2025-SSDE-0001 2025-SEPA-0001

The King County Wastewater Treatment Division (WTD) has received the Notice of Application and Optional DNS Process for the Lakefront Park Improvements project (2025-SSD-0001, 2025-SCUP-0001, 2025-SVAR-0001, 2025-ZCUP-0001, and 2025-SEPA-0001) located at 17337, 17345, and 17347 Beach Dr NE that proposes improve public waterfront access through the transition of two recently acquired single-family residential properties into a public waterfront park. The newly acquired properties will be integrated with the existing Lyon Creek Waterfront Preserve to form one continuous public park. New project improvements include a new limited parking area, access paths, play structure, picnic structure, nature viewing platforms, and new swimming and paddling dock and recreational float. The existing primary single-family dwelling and one existing accessory unit will be renovated for flexible community use, and a bathhouse will be constructed in the footprint of the existing garage building. Other existing accessory structures will be permanently removed from the site. Two existing docks will be removed and consolidated into a single dock for public water access uses.

Figure 1: Critical areas mapped by Lake Forest Park Interactive Map

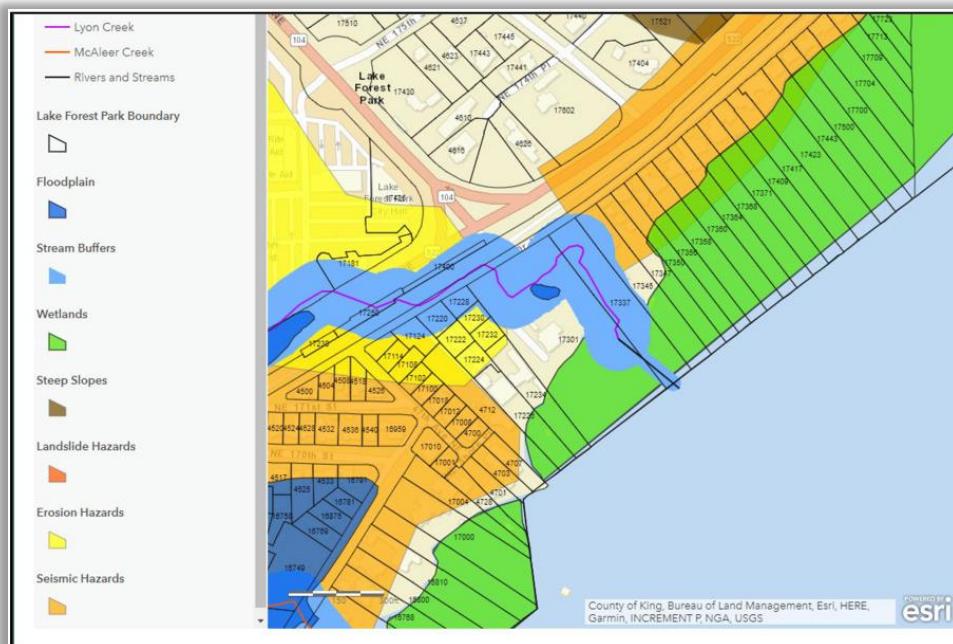
These mitigation measures, while the beginning of an adequate analysis, are not a substitute for a comprehensive environmental study of this complex overlap of wetlands and streams, critical aquifer recharge areas (“CARAs”), fish and wildlife habitat areas, geological hazards, and frequently flooded areas, and do not address all potential environmental issues present in the Project. See Figure 1 for an overview of complex overlap.

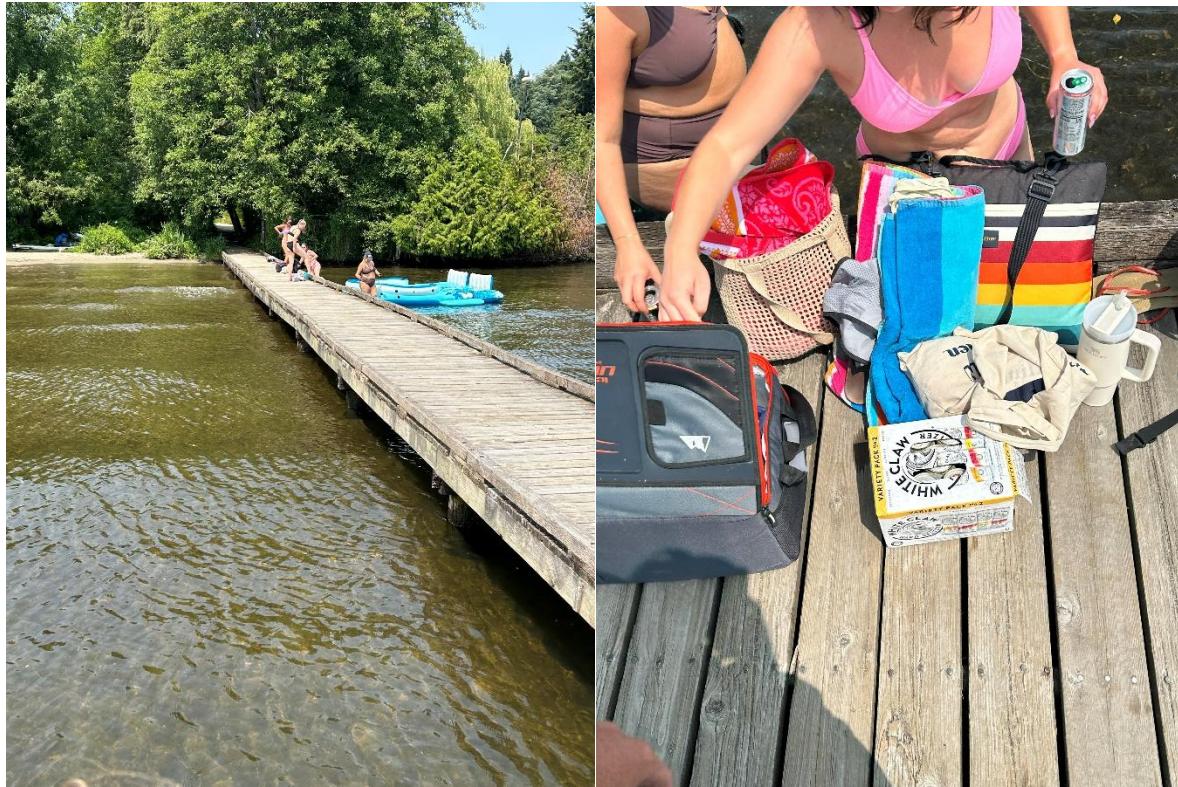
The proposed parking lot and walkways will encroach slightly within 25 feet of the easterly adjacent RS property;

The parking lot is within 5 ft of the side of our house, which is on the property line. The City states it will "encroach slightly" when in fact is 20 ft into the setback. The parking lot is particularly impactful encroachment because of the noise and pollution produced. Every car reaching the site will pass within 10 feet of our property, adjacent to our office and beneath our sons bedroom. The rear wall of the community center would be less impactful than the parking lot and turnaround.

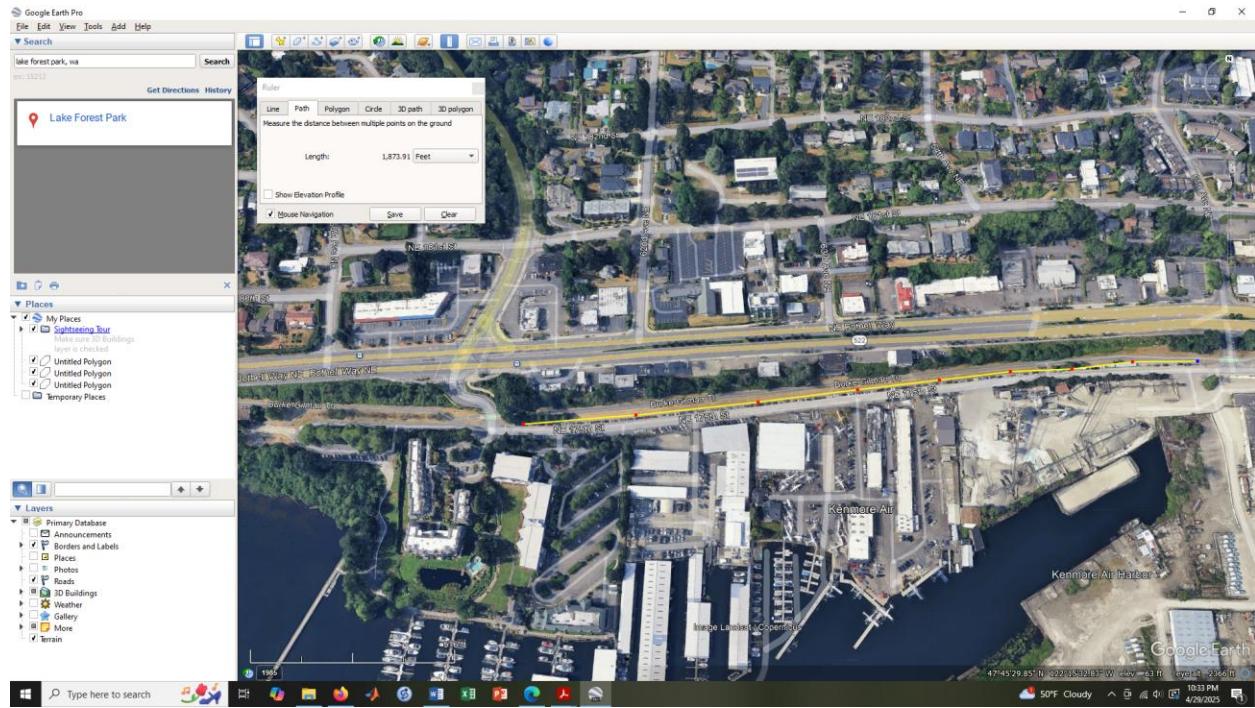
The City's analysis relies on a calculation of stalls per acre (see Table 9). This metric is deeply flawed as it does not account for intensity of use. Take New Castle Beach Park. The City lists it as a 42.48 acres with 161 parking spaces for a stalls/acre of 3.79. However, the park is actually much more similar to the proposed park than this suggests – there is a 130 linear ft beach, picnic shelter, dock with swim float, bathrooms, playground, proximity to a major trail (Eastrail) and open grass space (not sports fields). The two significant differences - no built assembly space and lots of undeveloped space. A reasonable assumption is that the use of the park depends not on the acreage, but rather the amenities. Thus, the appropriate number of parking spaces in a comparison to New Castle Beach would be a nearly equal amount of parking, say 160 parking spaces. We discuss this not to propose 160 spaces for the proposed park (see above where we suggest the Civic Club as the obvious comparison), but rather to highlight the inappropriateness of the City's comparison.

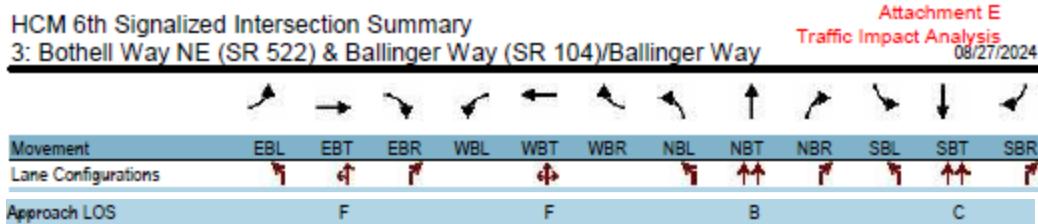
“The intersection of Beach Drive and the site entrance included one non-injury crash with a parked vehicle on October 12th, 2019. The Crash Rate per MEV is greater than 1.00 due to the low volume of the roadway.”

It is unclear why the report is discounting the crash rate per MEV being greater than 1.00. The proposed park will bring many more bike/car/pedestrian encounters and this is clearly a warning sign that the intersection requires analysis and mitigation.
